# System Strength Impact Assessment Guidelines

Version: 2.12

Effective date: ~~6 June 2023~~ July 2024

Status: ~~FINAL~~DRAFT

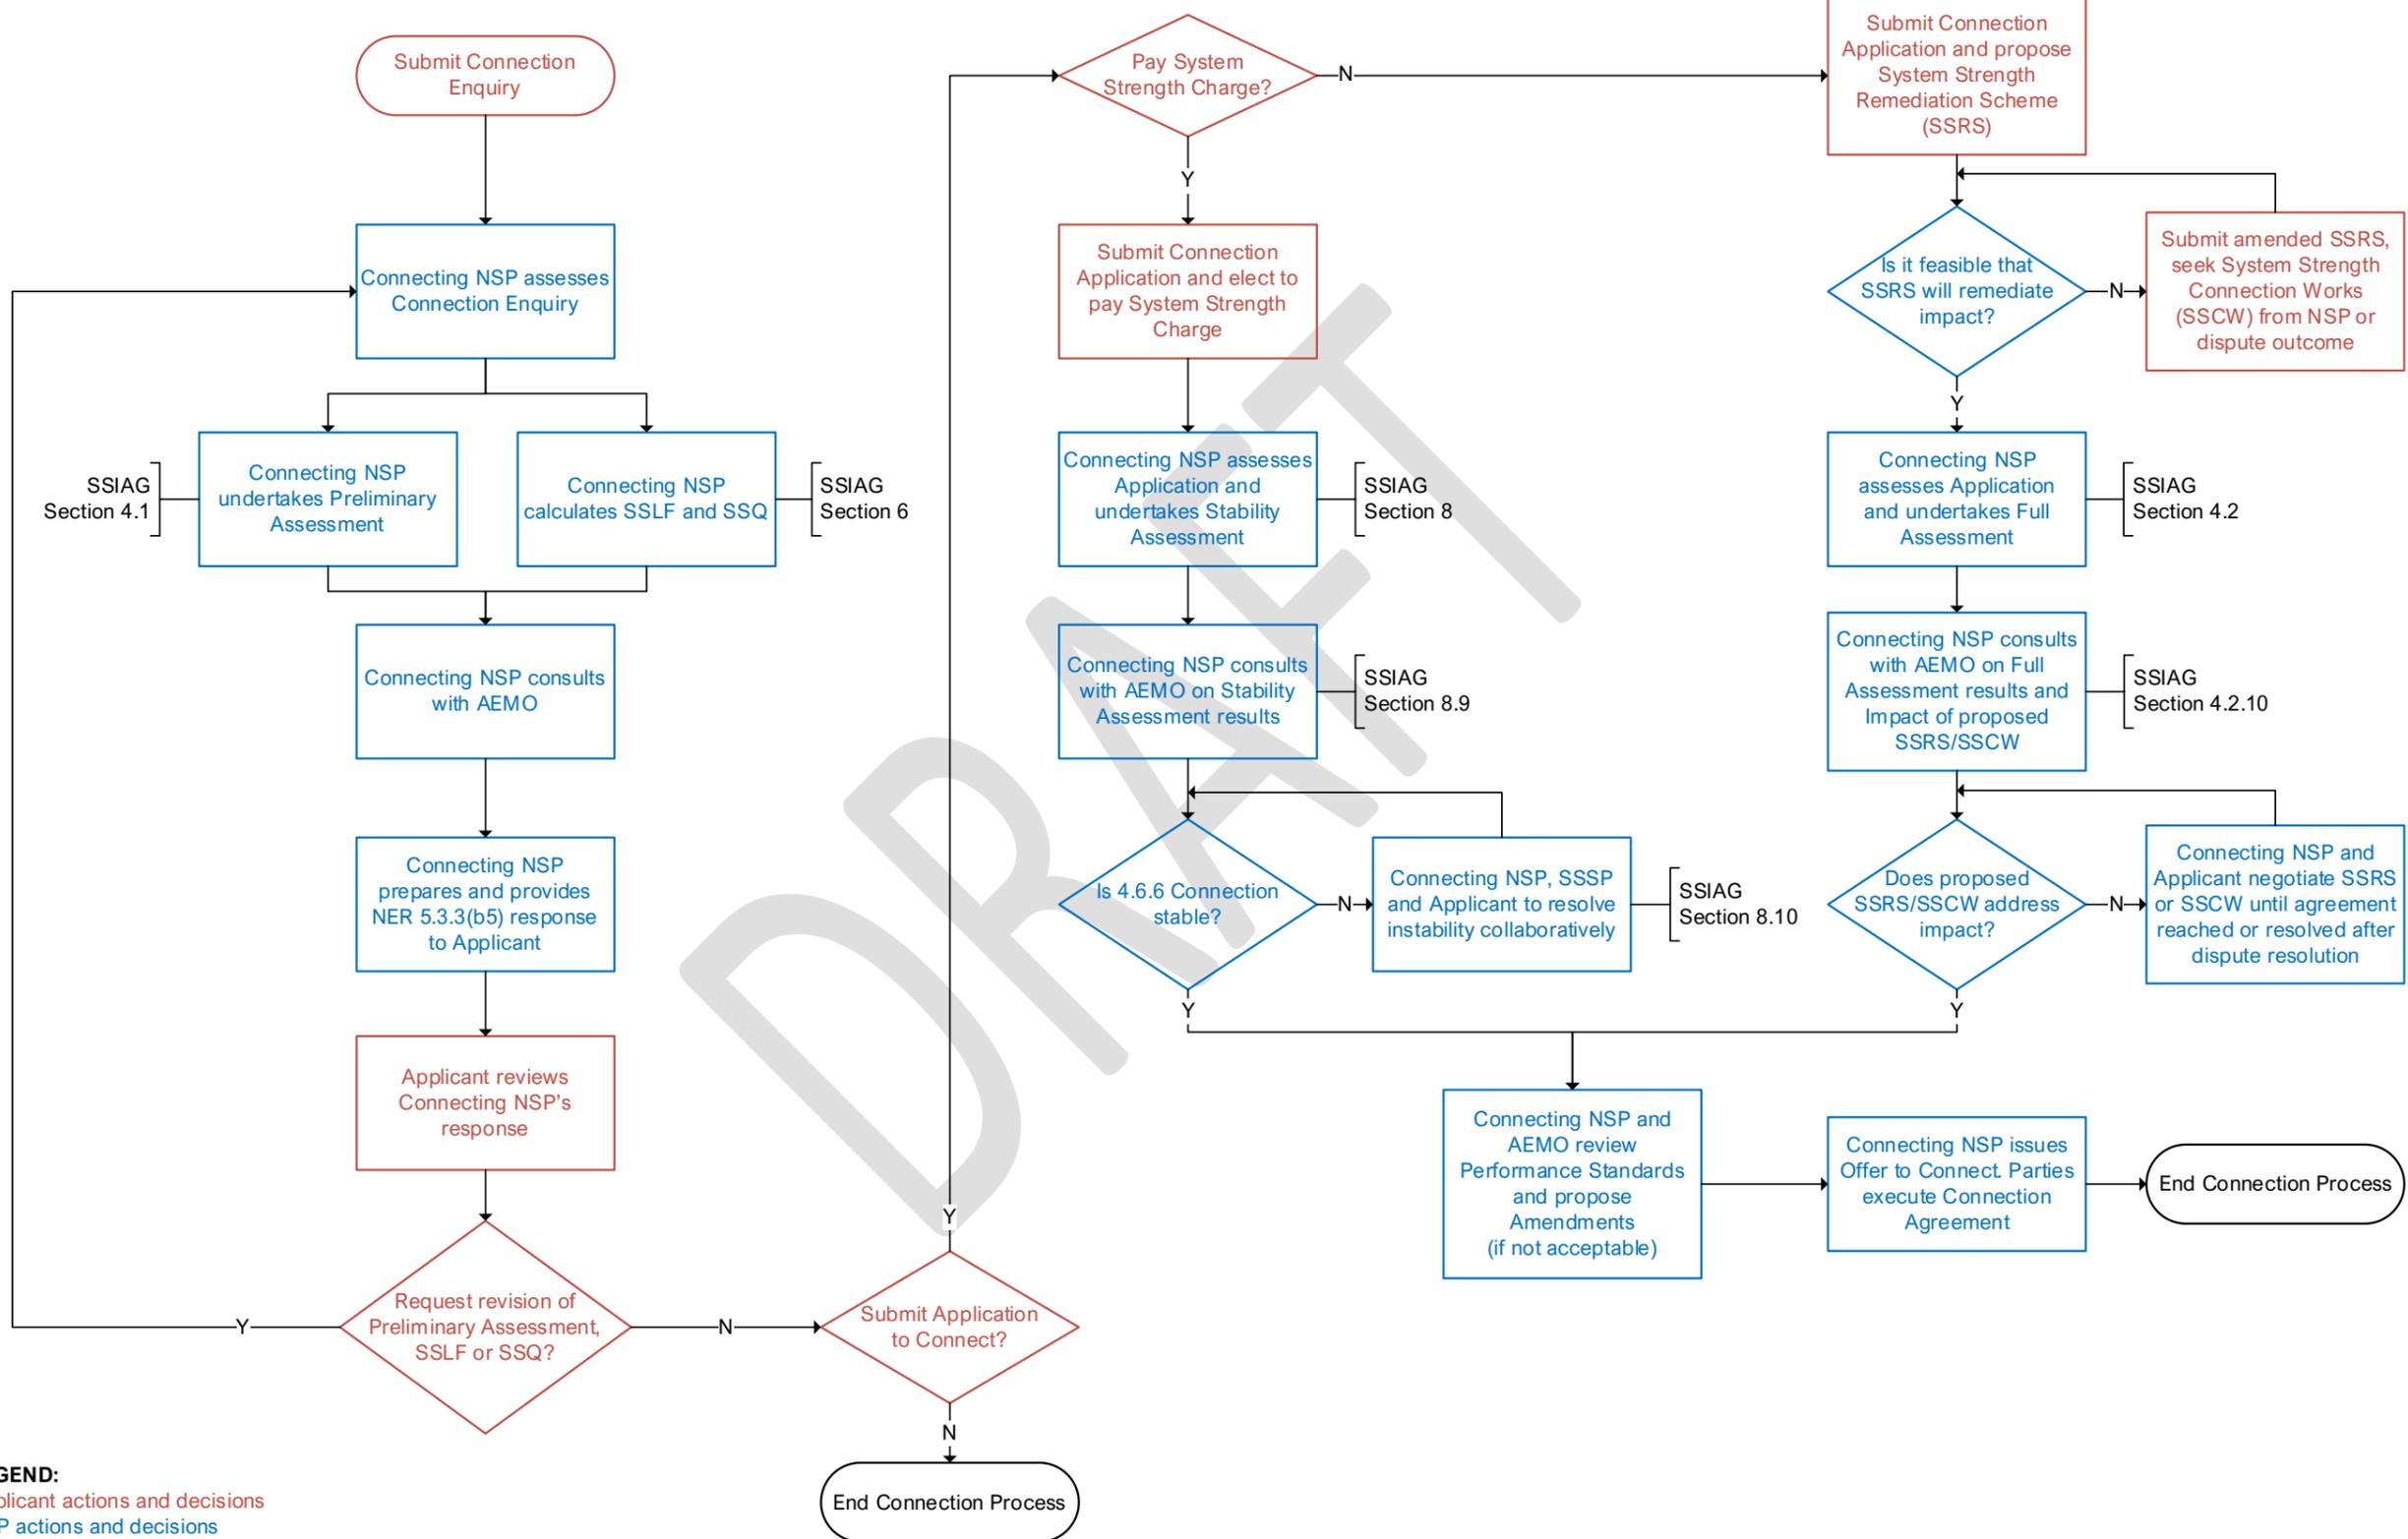
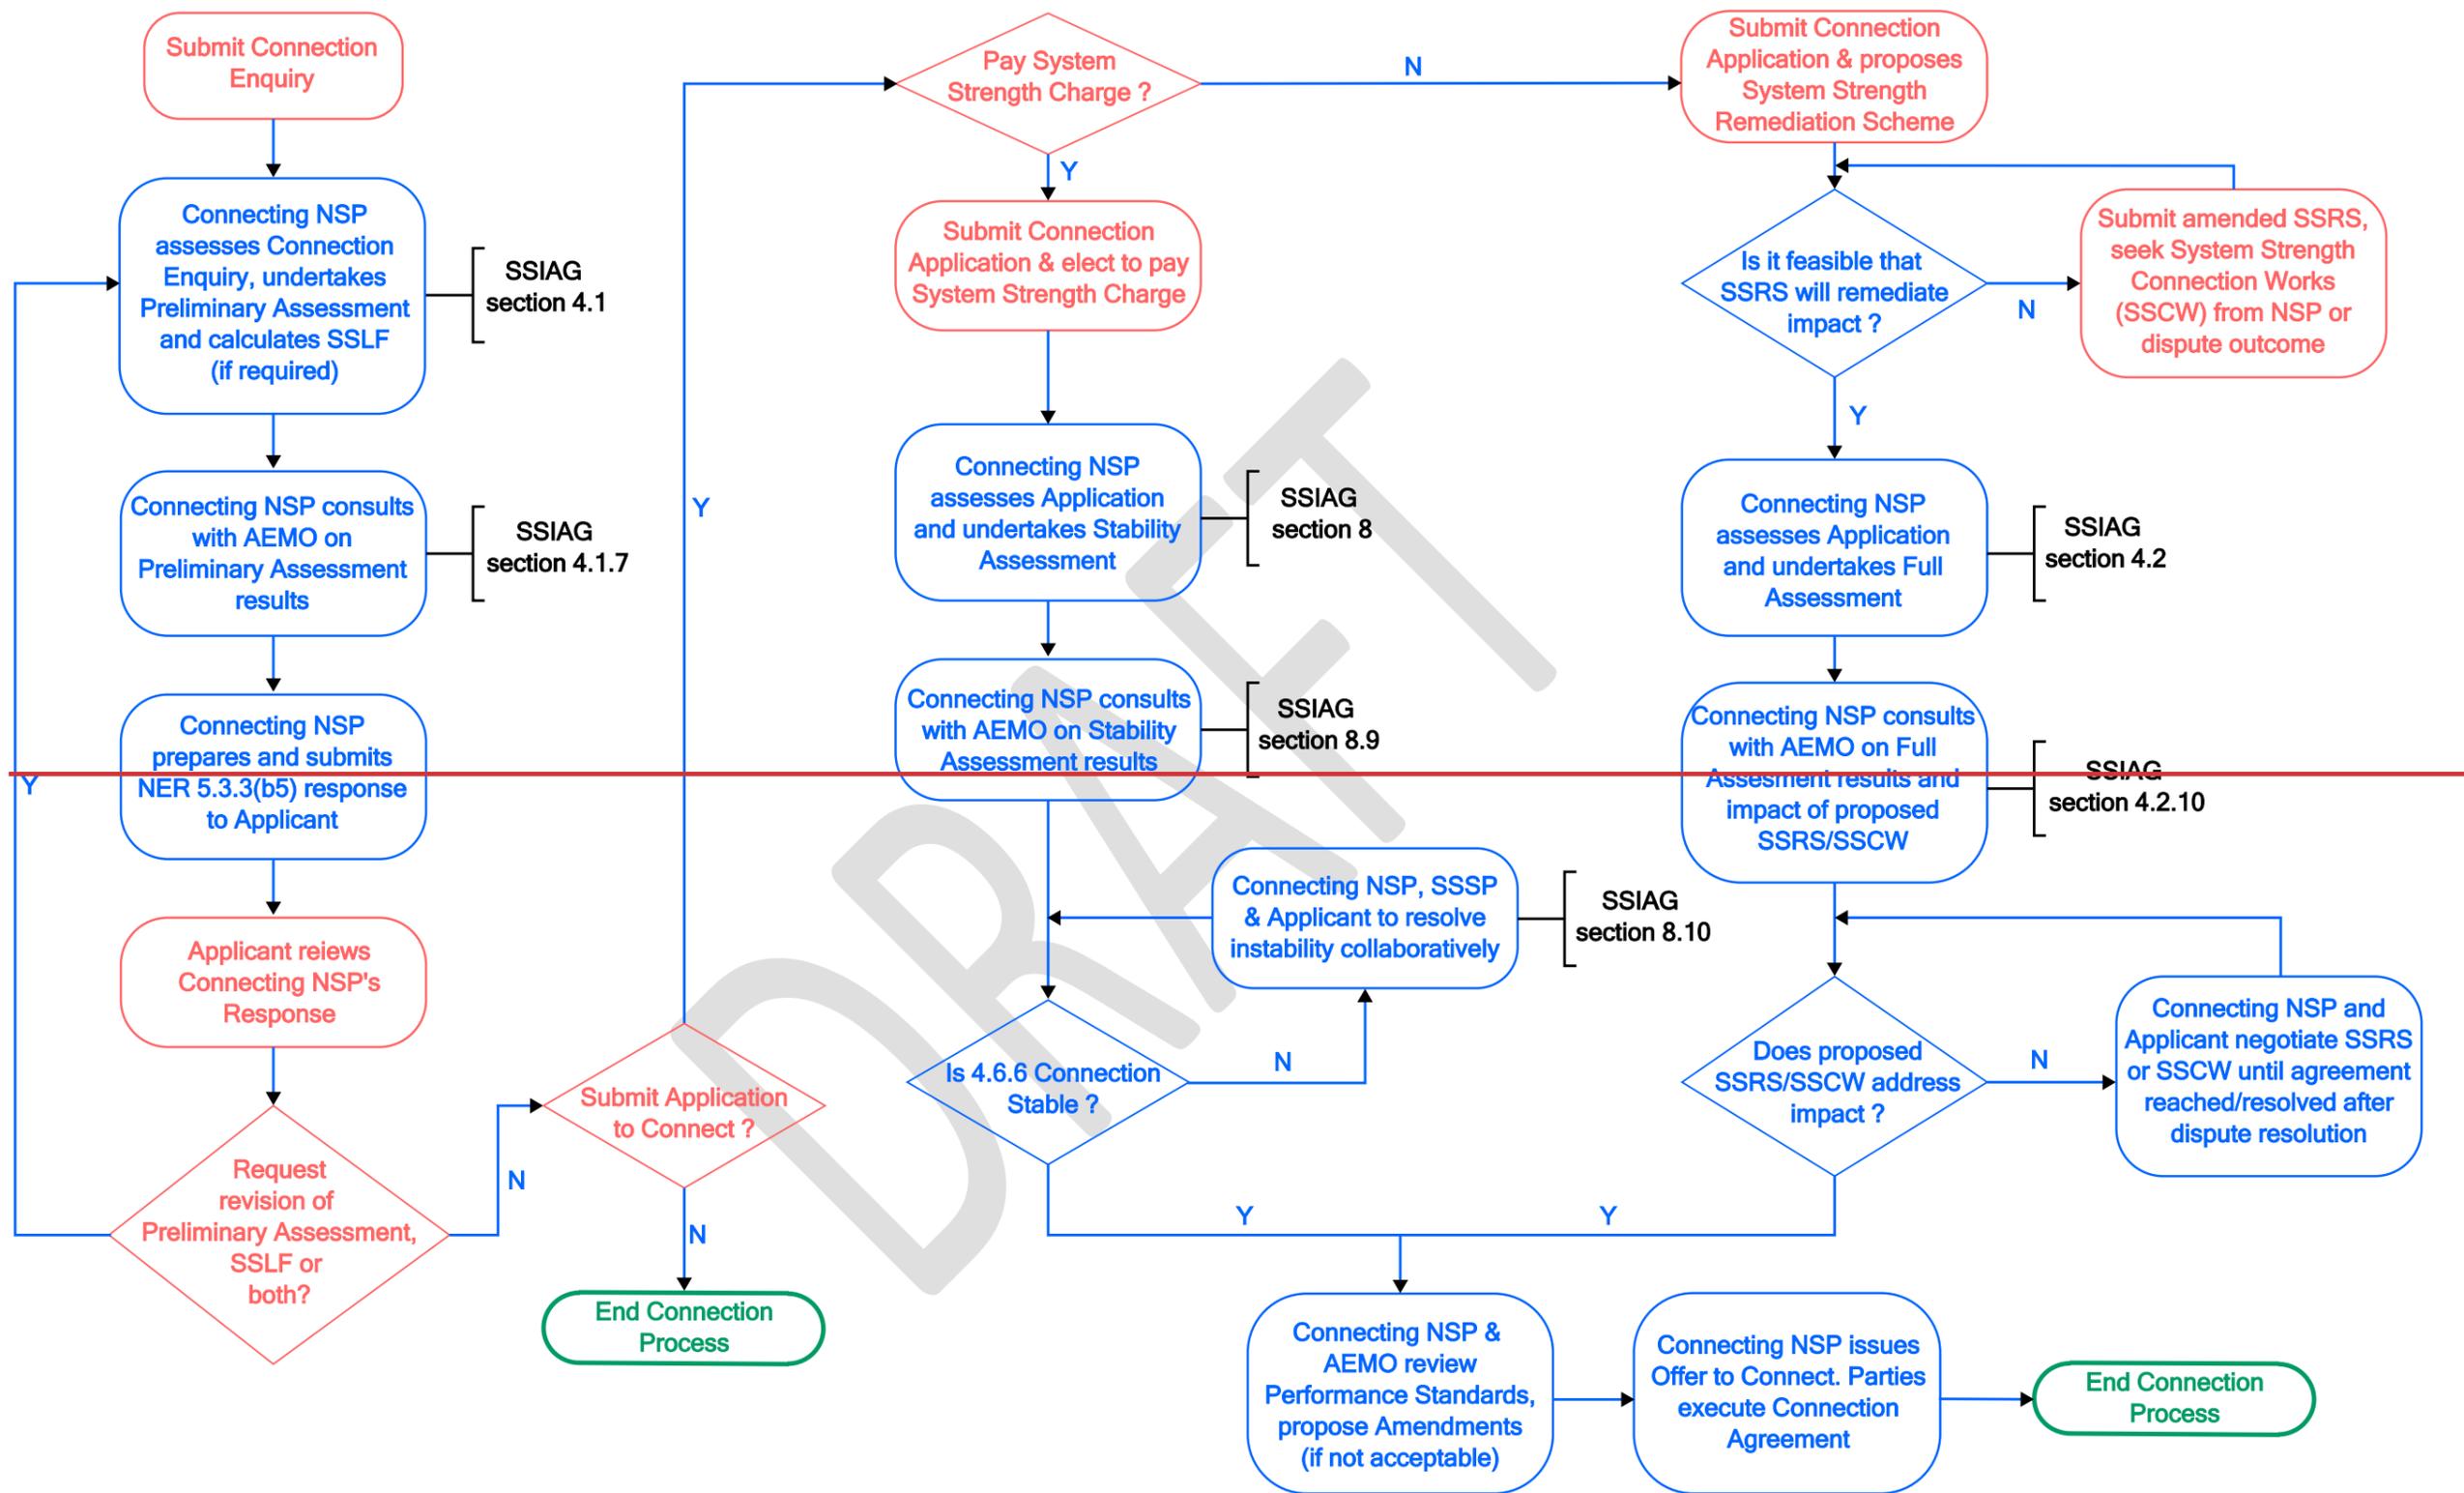
**Figure 3** System strength impact assessment process within connection process *[drafting note: this figure has been re-created and amended to identify the respective sections of the SSIAG for which the Connecting NSP undertakes the Preliminary Assessment and calculation of SSLF and SSQ. Due to the nature of the figure this has not been change marked.]*
